**SIERRA CLUB PETITION**

**EXHIBIT 2**

**Re: Comments on Draft Prevention of Significant Deterioration Construction Permit for Power Holdings of Illinois, LLC (DLC # 347-08)**

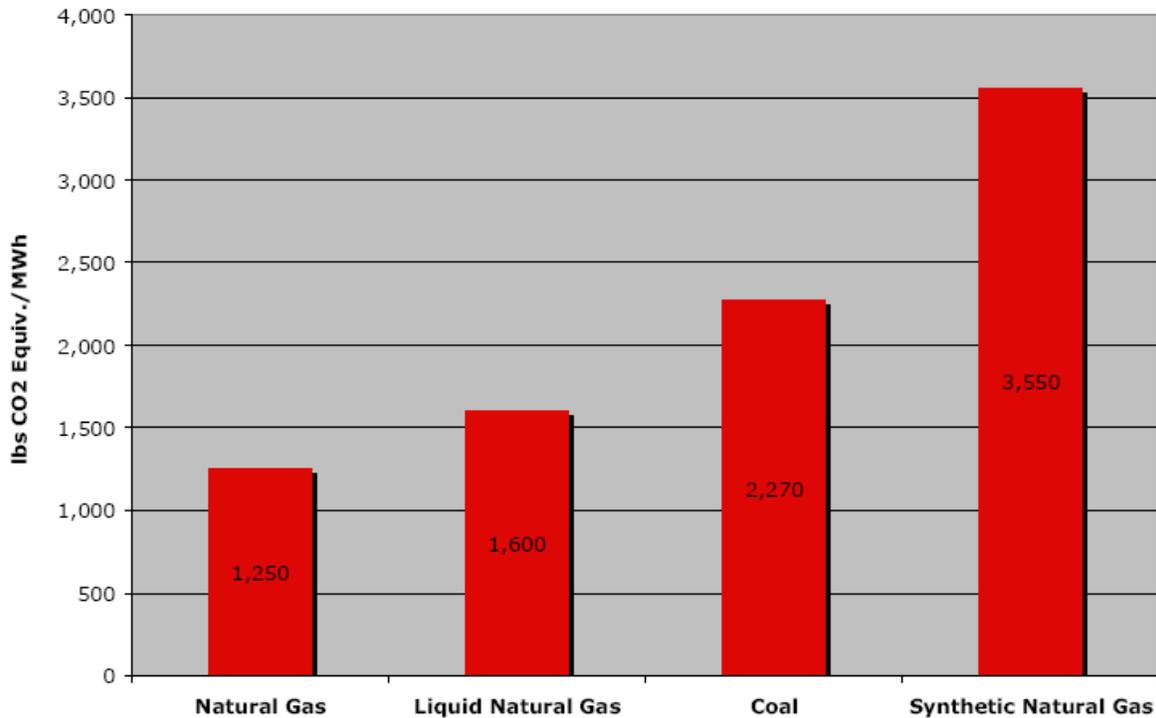
Power Holdings’ website advertises that the project would “separate[] about 90% of the carbon dioxide in the Syngas stream for possible use.”<sup>11</sup> In fact, the developer intends to take advantage of a recent law that gives special treatment to “clean coal SNG facilities,” *e.g.*, 220 ILCS 5/9-220(h), as amended by Ill. Pub. Act 095-1027, which is defined to require that the SNG manufacturing process “sequesters at least 90% of the total carbon emissions . . . .” 20 ILCS 3855/1-10.<sup>12</sup> Moreover, the project is already designed to include the Retisol system to separate carbon dioxide from the syngas. The sequestration of CO<sub>2</sub> must be considered in the top-down BACT analysis, and complete capture must be considered.

Despite its ability and publicly-announced plans to capture and sequester 90% of the CO<sub>2</sub> produced, Power Holdings does not include a carbon capture and sequestration proposal in its application. Instead, as proposed in the draft permit, the plant will be among the most GHG-polluting contraptions as shown in the chart below.
